APPLICATION NAME: BOWDENS SILVER MINE AMENDMENT
APPLICATION NUMBER: SSD5765
VISUAL IMPACTS

I **object** to this proposal (SSD 5765).

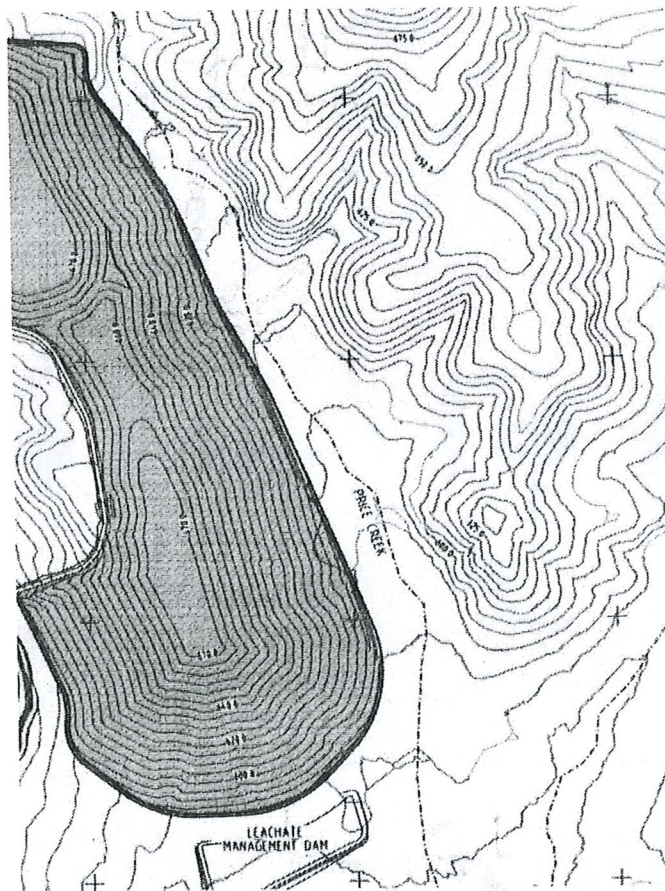
As I asserted a 100 metre high sand castle shaped pile of rocks is a negative outcome and should not be allowed. Is the reader of the proposal documents looking at drawings meant to conclude any different. Simply described the WRE is:

It has slab or planar sides without any natural contour design (nothing like the hills behind it)

The slab sides are at a constant angle of about 25 degrees

The slab sides meet at a ridge (narrow with enough room for single vehicle track)

The ridge is near enough to horizontal (dead straight like a cottage roof or a railway siding grain shed.)...totally unnatural.

This is an appalling feature to foist onto our visual experience but Bowdens propose to leave it like that for ever. Look at it graphically this is a Bowdens map of the WRE.

The shaded mass is the WRE. All but for a tiny wiggle the contours are straight. They are also equally spaced...meaning constant slope. To the right (east) of Price Creek is natural landform. Chalk and Cheese. And furthermore those tiny wiggles are at such a scale invisible; they could simply appear as rough dozer work. It is time for some honesty about the proposal.
